SERVICE BULLETIN

No. 181

Piper Aircraft Corporation

SUBJECT: Replacement of 1/8 - 7 x 19 Flexible Stainless Steel Control Cables

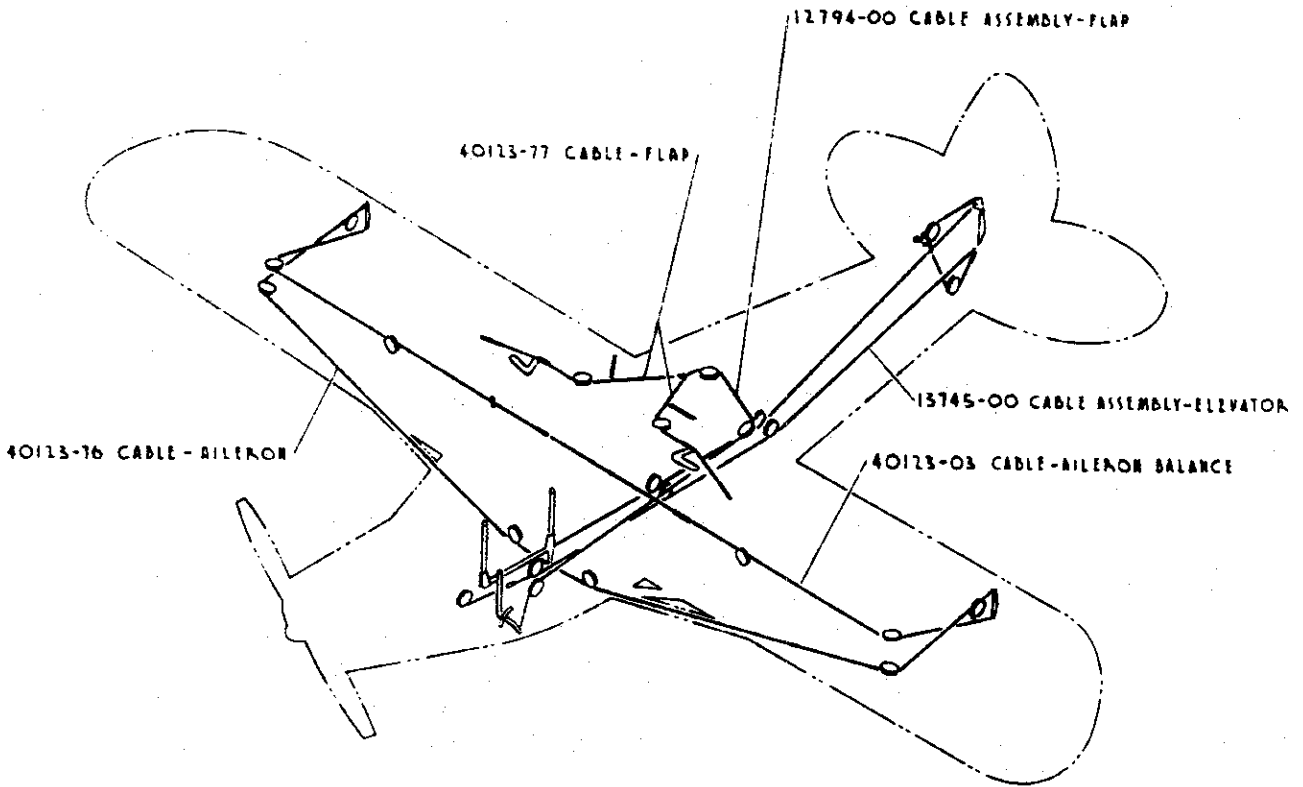
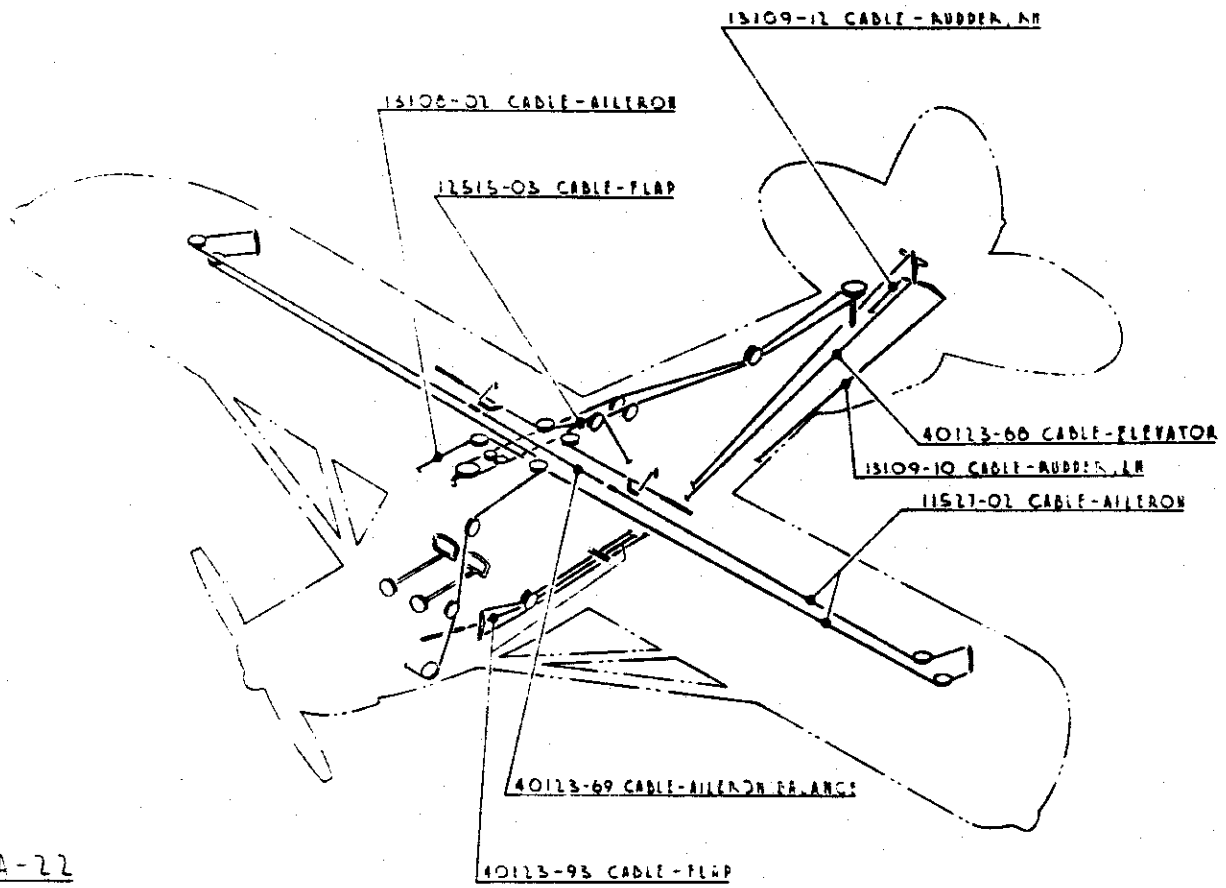
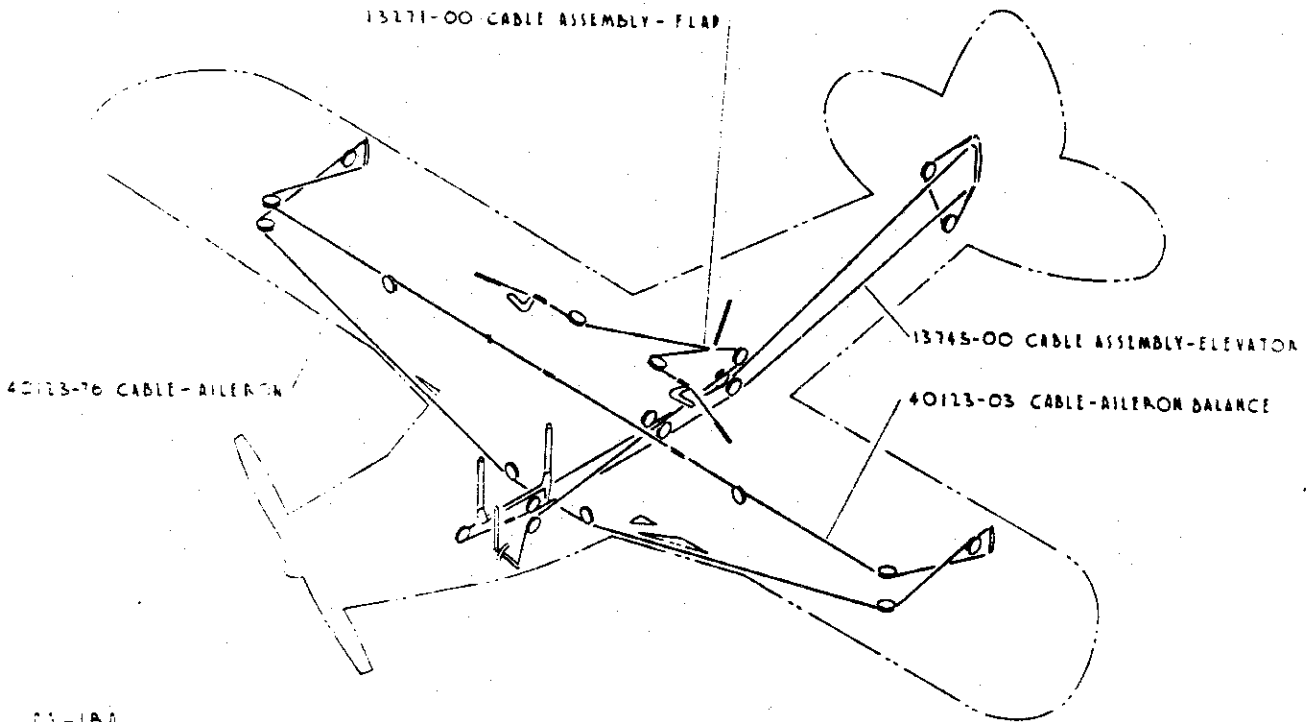
The following is a list of the affected control cables and their respective replacement parts which apply to the aircraft serial numbers listed after "MODELS AFFECTED", exclusive of the aircraft listed under Note "A". See sketches A, B and C for identification.

Replace			Install		
Stainless Steel Cables	Qty.	Nomenclature	Replacement Cables	Aircraft Application	
Part No.	Req.		Part No.	PA-18	PA-18A
12794-03	1	Cable - Flap	12794-00	X	
13271-02	1	Cable - Flap	13271-00		X
13745-02	1	Cable - Elevator, lower	13745-00	X	X
40123-44	2	Cable - Aileron	40123-03	X	X
40123-86	2	Cable - Flap	40123-77	X	
40123-87	2	Cable - Aileron	40123-76	X	X

Replace			Install	
Stainless Steel Cables	Qty.	Nomenclature	Replacement Cables	
Part No.	Req.		Part No.	
11527-03	4	Cable - Aileron	11527-02	
12515-04	1	Cable - Flap	12515-03	
13108-03	1	Cable - Aileron	13108-02	
13109-13	1	Cable - Rudder, LH	13109-10	
13109-15	1	Cable - Rudder, RH	13109-12	
40123-83	1	Cable - Elevator	40123-68	
40123-84	1	Cable - Aileron balance	40123-69	
40123-94	1	Cable - Flap	40123-93
